# ADDENDUM

**RFB NO. 322027 - ADDENDUM NO. 5**

**WINDOWS REPLACEMENT**

**WINDOWS REPLACEMENT**  
**CITY-COUNTY BUILDING**  
**210 MARTIN LUTHER KING JR**  
**BLVD**  
**MADISON, WI 53703**

**1 WEST SECTION ELEVATION - (South Carroll St.)**  
W904 3/32" = 1'-0"  
0' 4' 12' 24' 48'

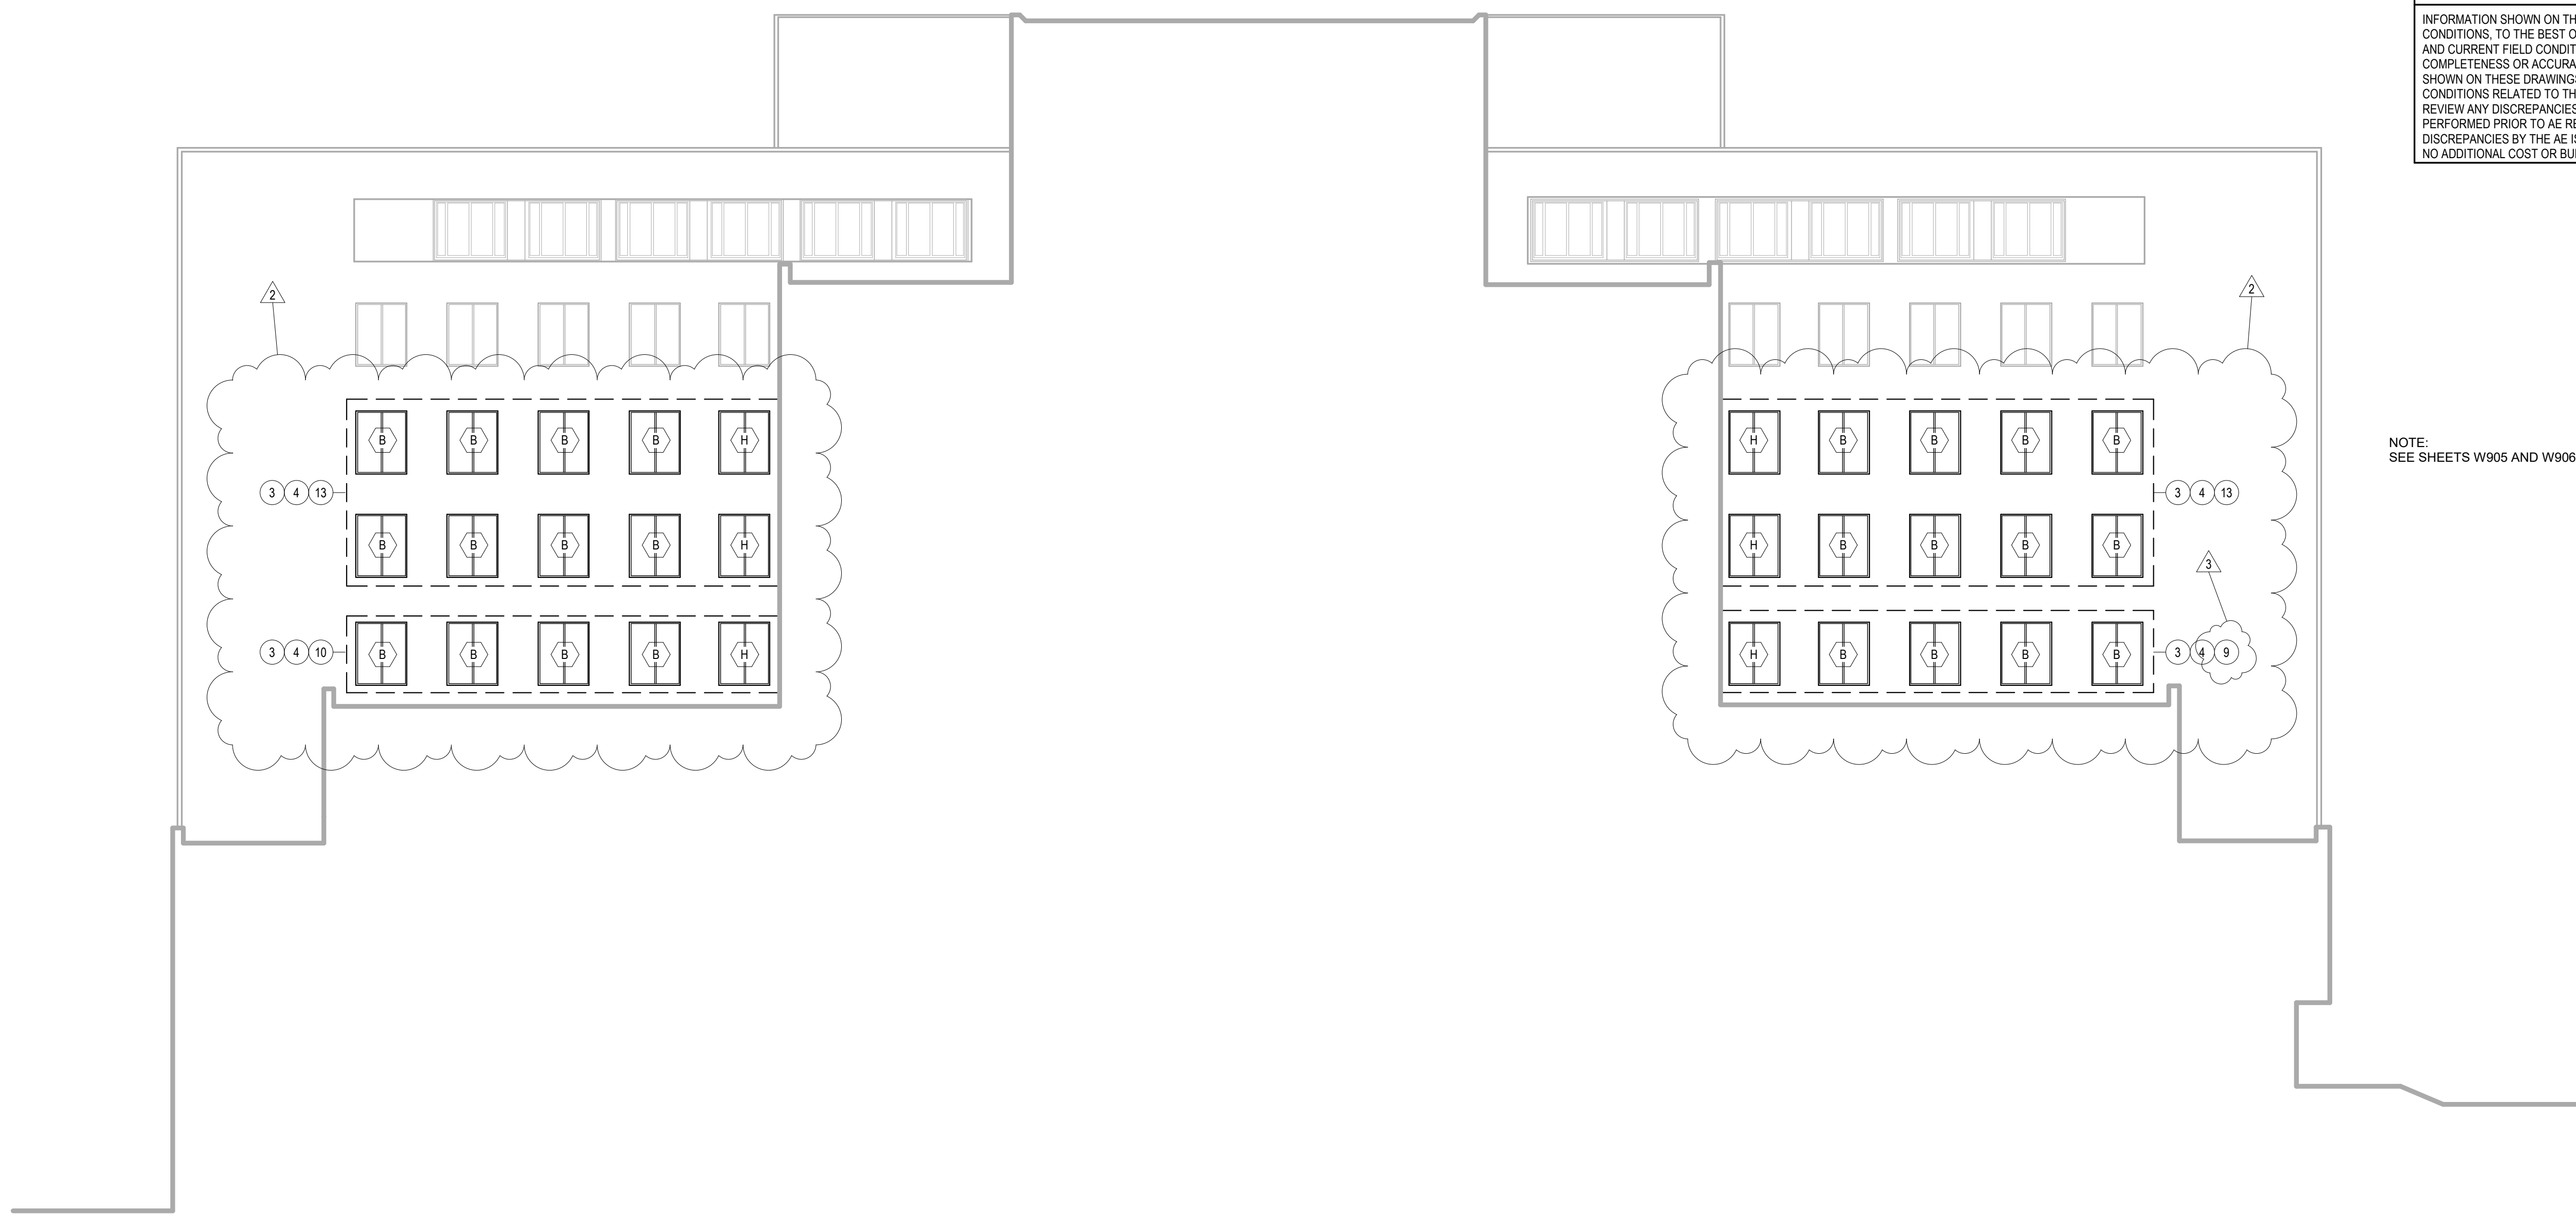
**1. Sheet W904**

Delete current Sheet W904; replace with new Sheet W904, issued with this Addendum.

- Q3** Please confirm that Alternate 3 does not include any scope after addendum 4 revised the scope of Alternate 3 and 4.
- A3** This Addendum #5 to cover revision including scope of Alternate 3.
